REZONING
PLAN

SHEET
Z1

PETITION No.
2004-150

SUBJECT: Administrative Approval for Petition No. 2004-150 by Sunshine House Day Care.

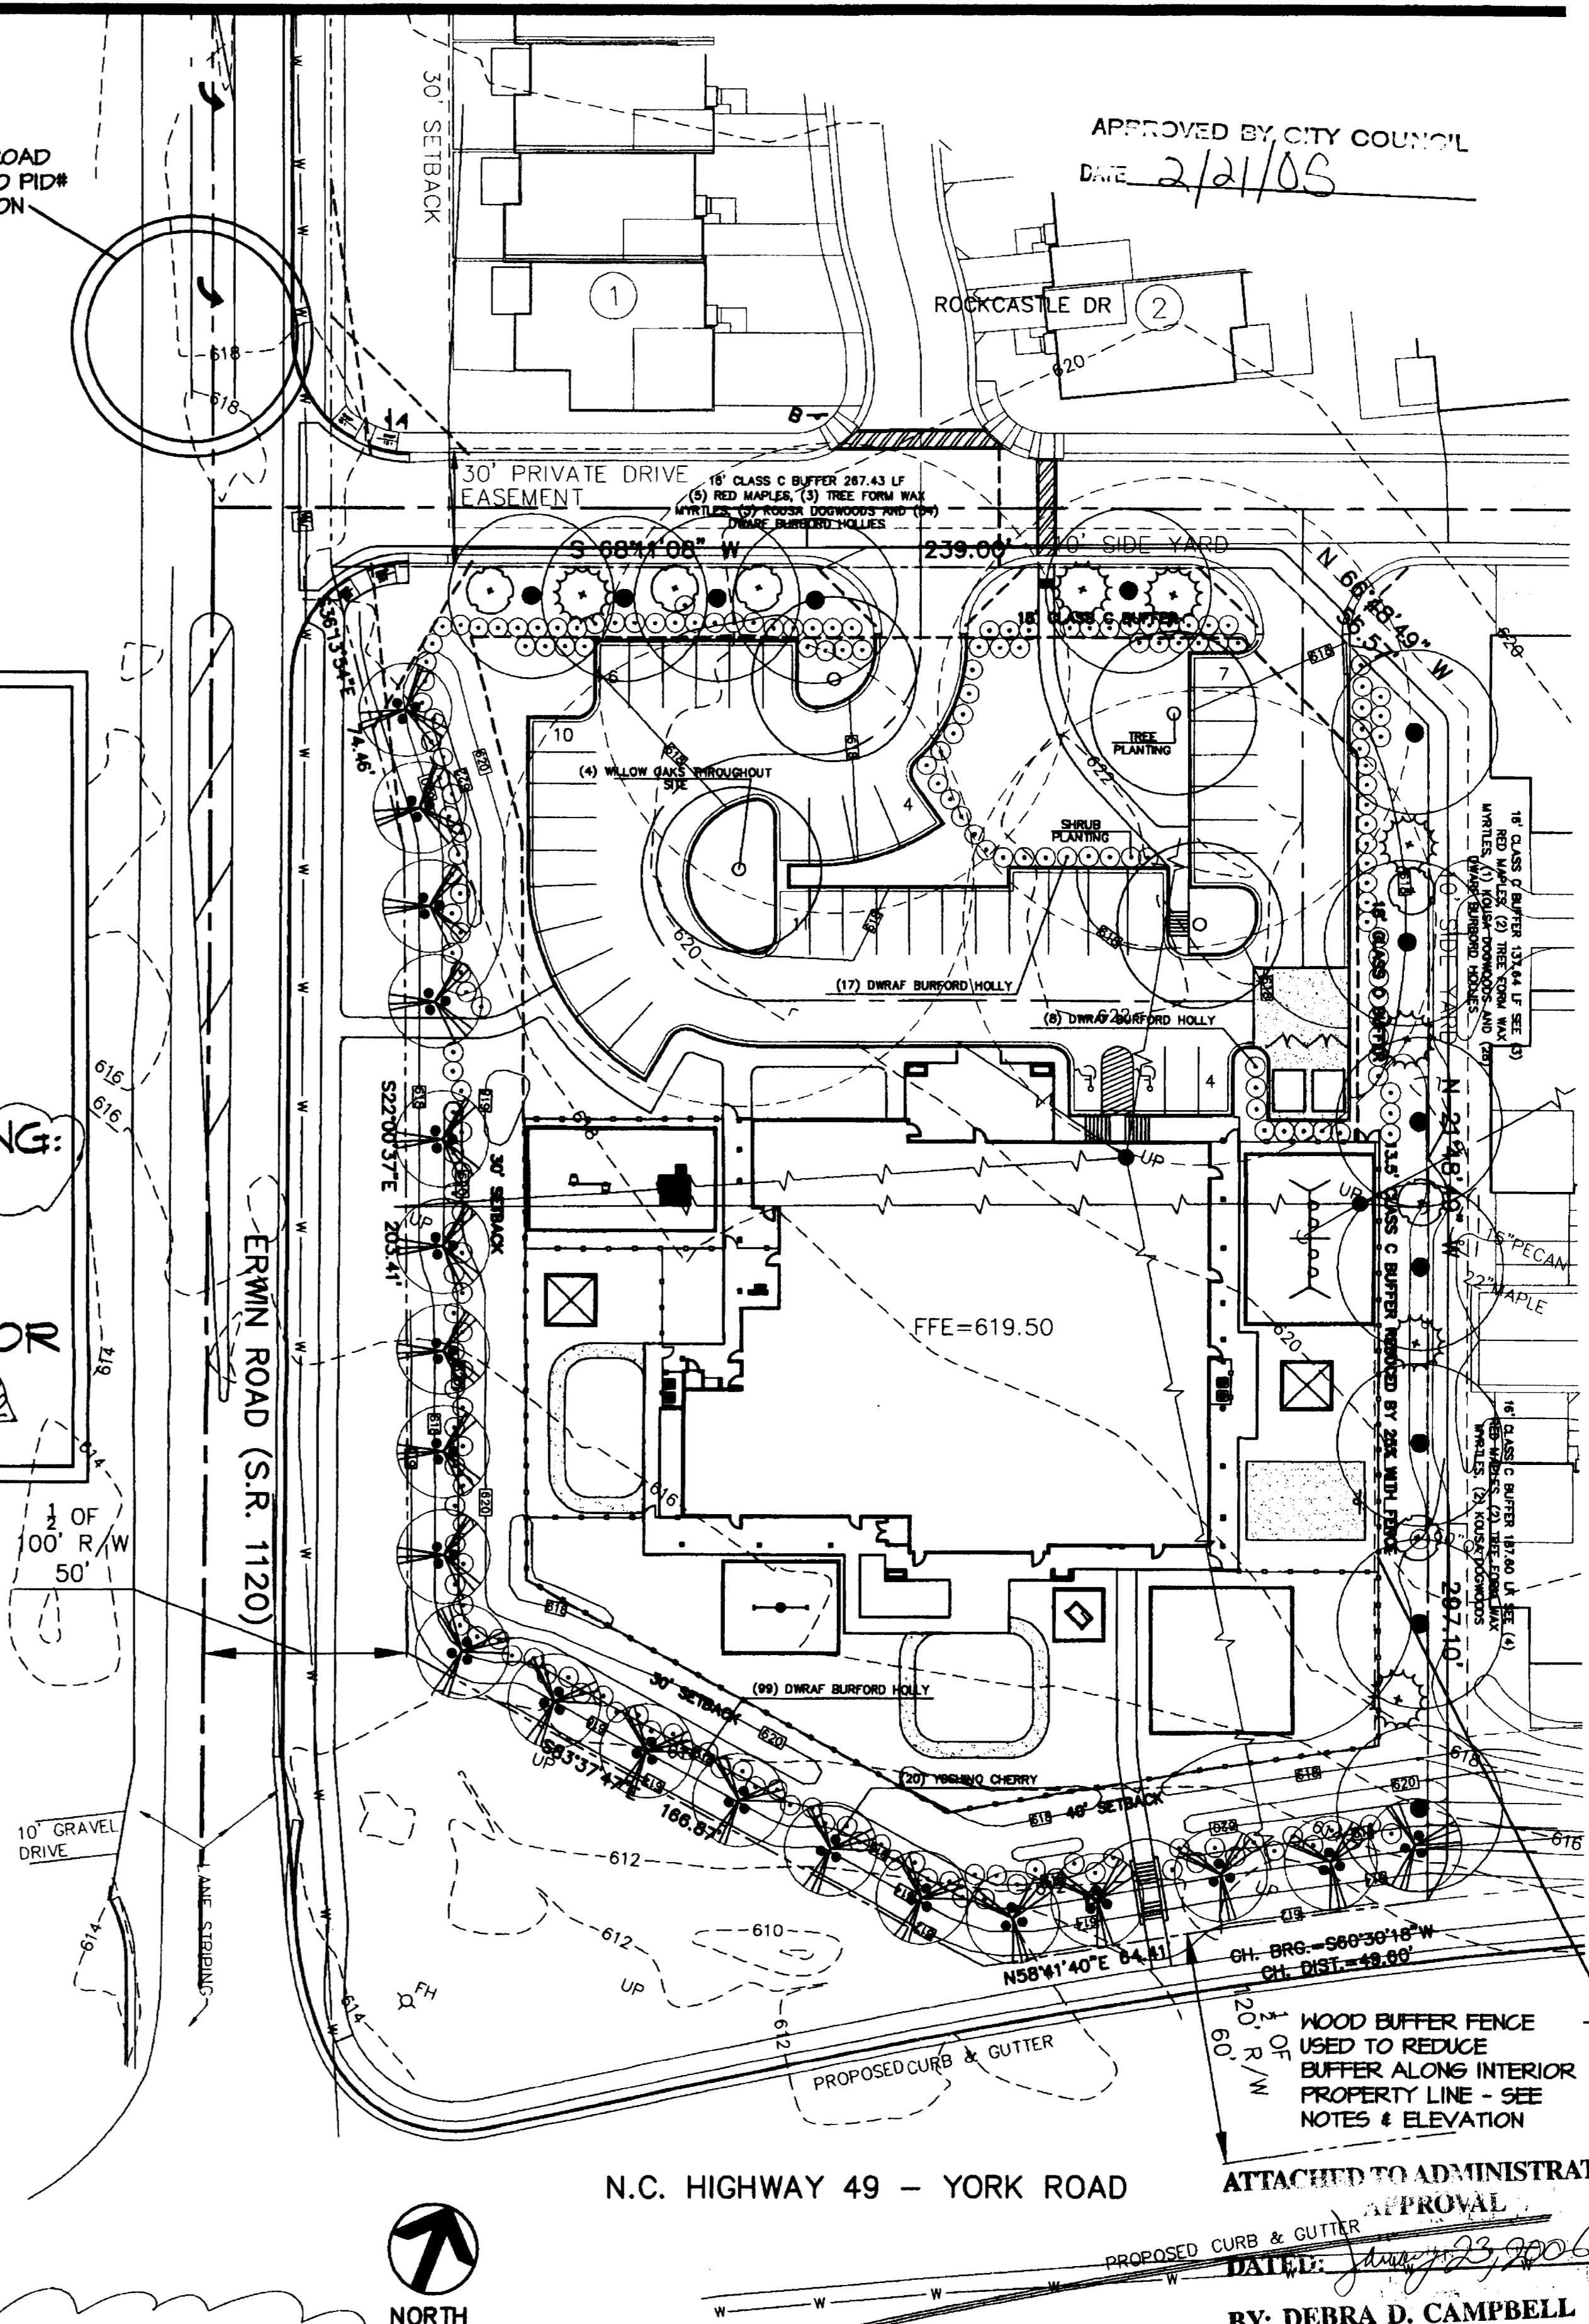
Attached is a revised site plan for the above petition to allow an additional 5 children or 195 total children. Since this change is minor and allowed by the Zoning Ordinance, I am administratively approving this revise sheet plan. Please use this plan when evaluating requests for building permits and certificates of occupancy. **Note that all other ordinance and signage requirements still apply.**

PROPOSED USE:
12,200 SF
DAYCARE FOR
UPTO 195
CHILDREN
